RE: **#06ITB49977K-RS, Southwest Arts Center**

Addendum No. 3

SW Arts Phase II Performance Theatre
ITB No. 06ITB 49977K-RS
Addendum 3
6/21/2006

PROJECT NAME	PROJECT NO.	DATE	SHEET NO.
FULTON COUNTY SW ARTS CENTER PHASE II	01145	6-16-06	SK38
SHEET TITLE	REF. SHT.	REVISION	SCALE
FLOOR PLAN	A2	Addend. #3	1/16" = 1'-0"

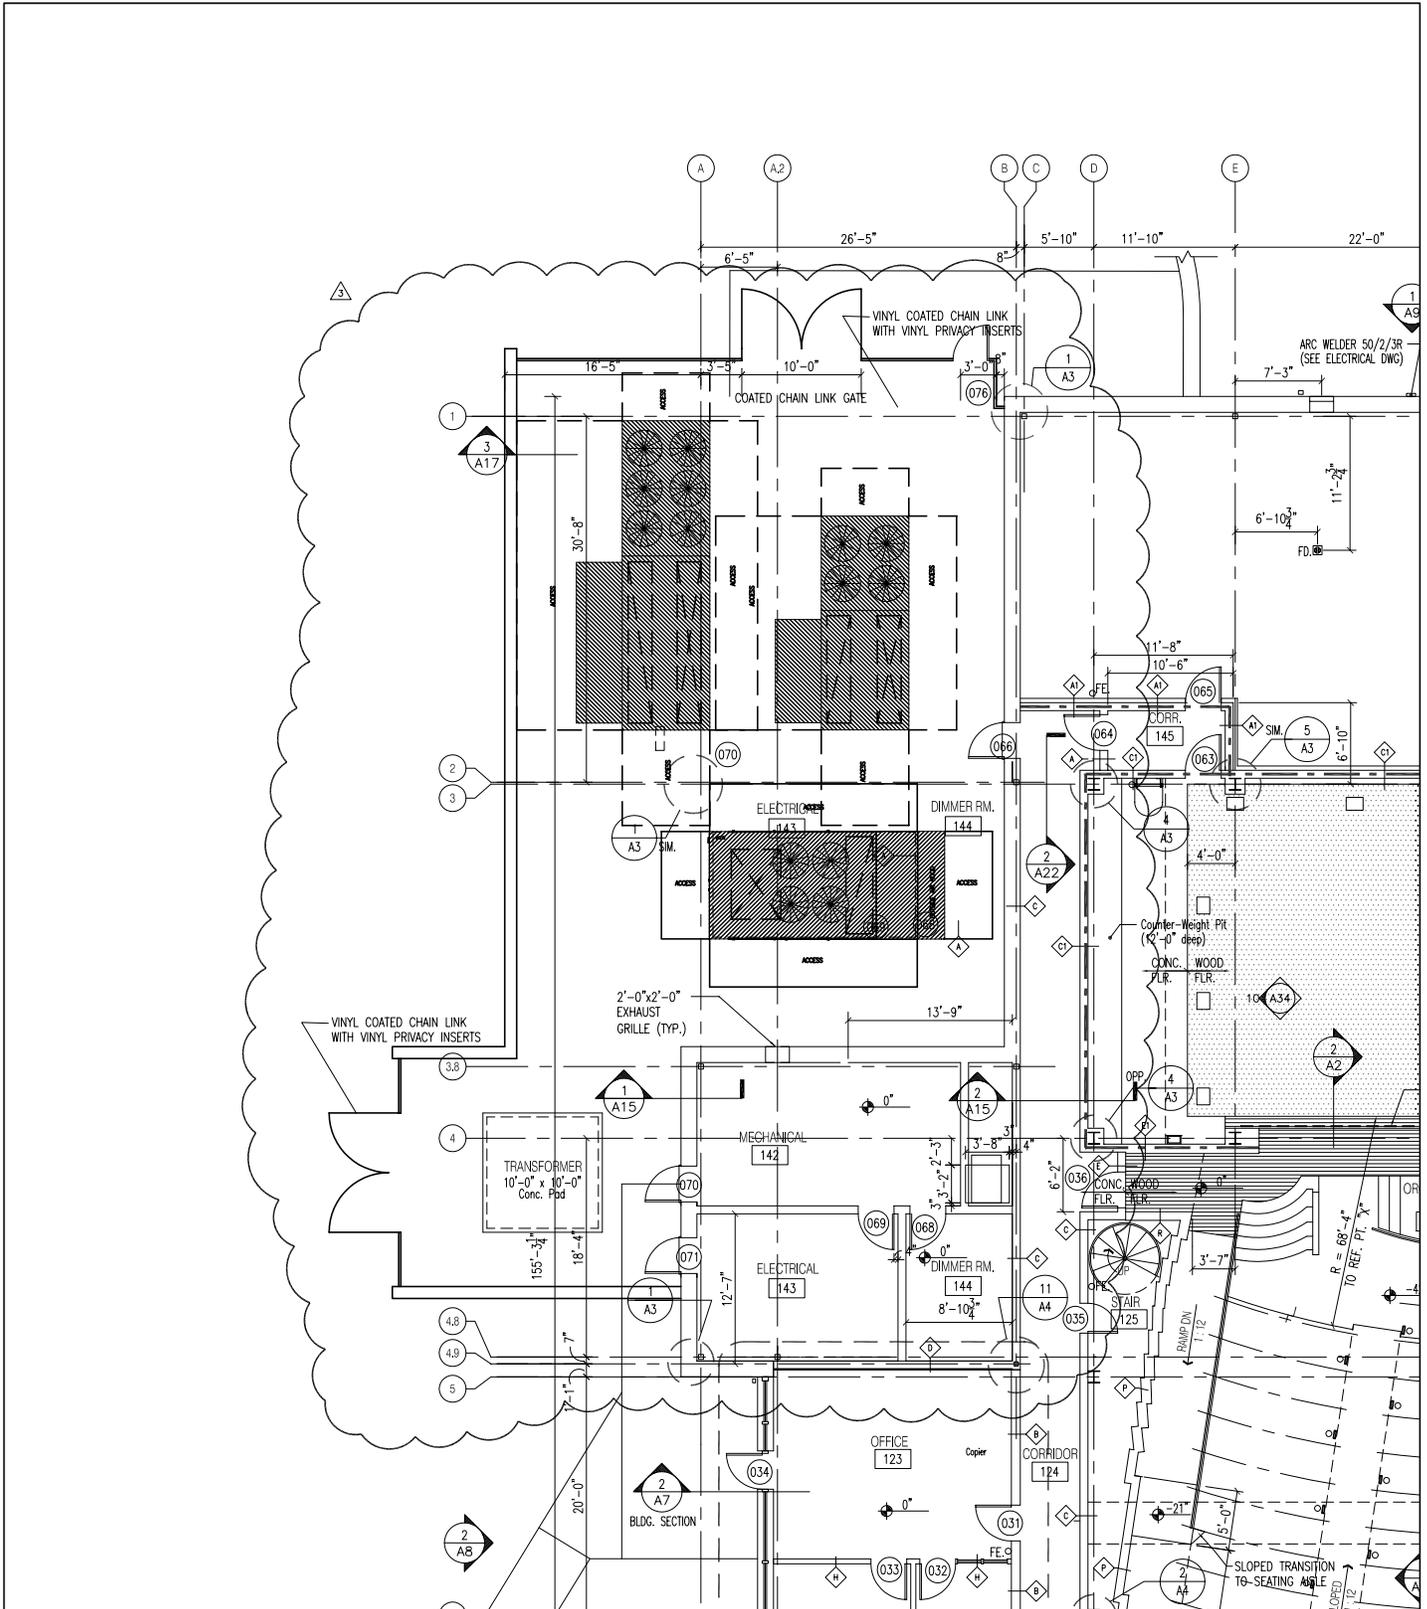
Add drawings SK 38, SK 39, SK 40, SK 41, SK 42, SK 43, SK 44, SK 45, SK 46, SK 47, SK 48, SK49, SK50, and SK51 to revise the floor plan, reflected ceiling plans at mechanical room, electrical room and dimmer room; delete fire pump room and consolidate with mechanical. Revise mechanical courtyard and layout of alternate mechanical units and ducting into the building. Revise the location of the water and fire main entrances into the building and associated riser diagrams. Delete Door 069.
